# UNITED STATES PATENT AND TRADEMARK OFFICE

APPLICATION NO.	FILING DATE	FIRST NAMED INVENTOR	ATTORNEY DOCKET NO.	CONFIRMATION NO.
10/666,542	09/19/2003	Thomas R. Apel	TRQ-12923	5554

## Office Action Summary

## DETAILED ACTION

**Fig. 2**  
PRIOR ART

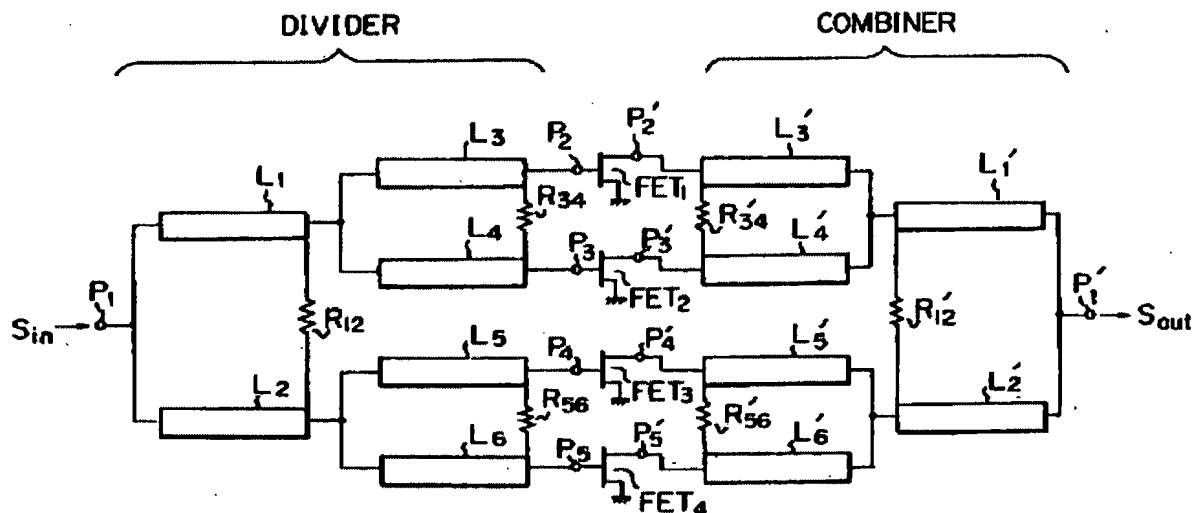
Figure 2 of Taniguchi discloses a power amplifier circuit. Note that the goal of these circuits of Taniguchi is to “obtain a high power high frequency signal” (See column 3, around line 59) and thus these circuits are power amplifier circuits. Taniguchi includes a first amplifier “subsection”  $L_3$  and  $FET_1$  (Herein and throughout referred to just as the first amplifier.) that is configured to receive an input signal that is the unmarked signal at the node that directly connects elements  $L_1$ ,  $L_3$ , and  $L_4$ . Note that the first amplifier receives this signal through element  $L_3$ . This is only giving the broadest reasonable

interpretation to the claims consistent with the specification. See MPEP 904.01. The first amplifier clearly provides a “first” output signal. Element  $L_4$  of Taniguchi is a first delay element that introduces a delay to the input signal and applies this to the input of a “second” amplifier “subsection”  $FET_2$  (Herein and throughout referred to just as the second amplifier.). This second amplifier clearly has an output signal and provides a “first” delayed output signal to the node directly connecting elements  $L_3'$ ,  $L_4'$  and  $L_1'$ . The top of page 9, of applicant’s specification clearly sets forth that an impedance inverter can be a quarter wavelength transmission line. Thus all the quarter wavelength lines of Taniguchi are “impedance inverters” as set forth by applicant and is in accordance with applicant’s application. These impedance inverters of Taniguchi are in accordance with applicant’s specification provides the “impedance inversion”. Thus the impedance/delay element  $L_3'$  also introduces a second delay to the first output signal thereby creating a second delayed output signal. The node directly connecting elements  $L_3'$ ,  $L_4'$  and  $L_1'$  and the node directly connecting elements  $L_5'$ ,  $L_6'$  and  $L_2'$  in combination with the node that directly connects elements  $L_1'$  and  $L_2'$  provides the means for combining the first and second delayed output signals that ultimately provides the high frequency amplified output signal  $S_{out}$ . This output signal is provided on the output terminal “ $P_1$ ’ ”. Taniguchi is silent on showing the bias circuit and supply circuit or what applicant calls “level control circuit” in claims like claim 1 for example that biases the first and second amplifiers to operate in the saturation range, i.e. non-linear classes of operation. Applicant should note that while Taniguchi is silent on the bias circuit or “level control circuit”. As is known to those of ordinary skill in the art, Taniguchi inherently must have a bias circuit and power supply circuit because this is a necessary circuit needed so that the amplifier(s) can operate.

The structure indicated above clearly provides for the claimed method of the claims indicated at the beginning of this rejection except for as indicated above Taniguchi is silent on providing a bias control circuit/level control circuit that biases the amplifiers such that non-linear operation is obtained.

Figure 2(Apel)

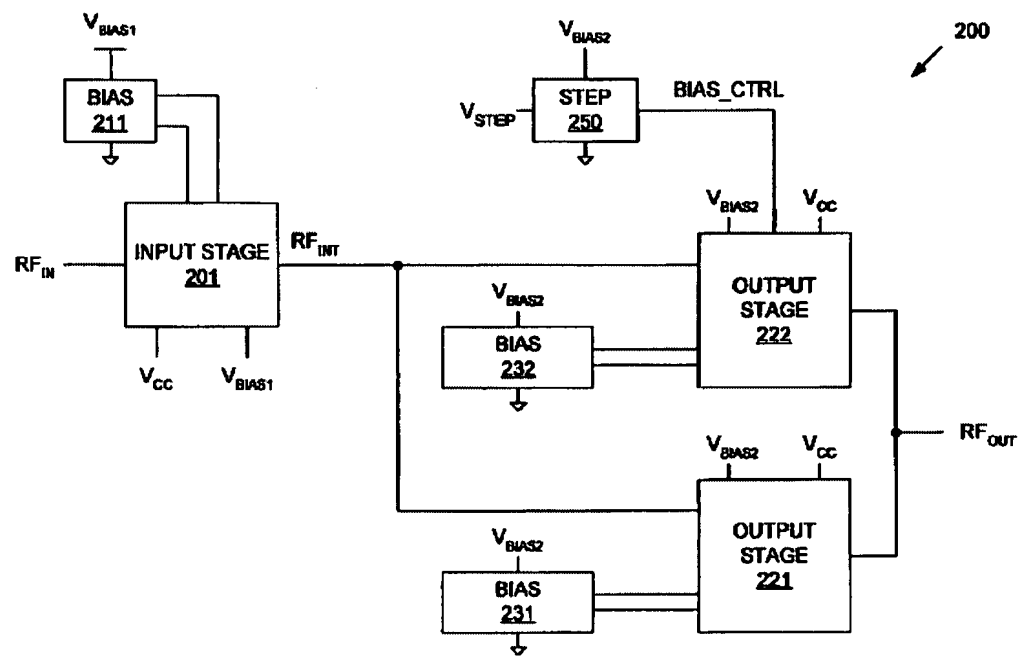
Figure 2 of Apel teaches one way to have a multi-channel amplifier arrangement provide for low power and high power modes. This includes the providing of a "bias control circuit" 231, 232, 250 that enables the first amplifier 221 when the "level control signal"  $V_{STEP}$  is set for a low power mode and which enables the second amplifier 222 when the "level control signal" is set for a high power mode.

Thus it would have been obvious to one of ordinary skill in the art at the time the invention was made to provide the combination of Taniguchi and Holt with a bias control circuitry such as that of Apel so as to enable the first amplifier during a low power mode indicated by a level control signal and enable

both the first and second amplifiers when the level control signal indicates a high power mode. Therefore the multi-channel amplifier arrangement can be made to provide more than one power level output mode as taught by Apel.

Note that the selection of the bias points of the bias circuits in the combination of Taniguchi, Holt and Apel results in the level control circuit, i.e. the unshown circuit that provides the level control signal  $V_{STEP}$ , to allow for the level control circuit to cause the first and second amplifiers to operate in the saturation mode when these amplifiers are enabled.
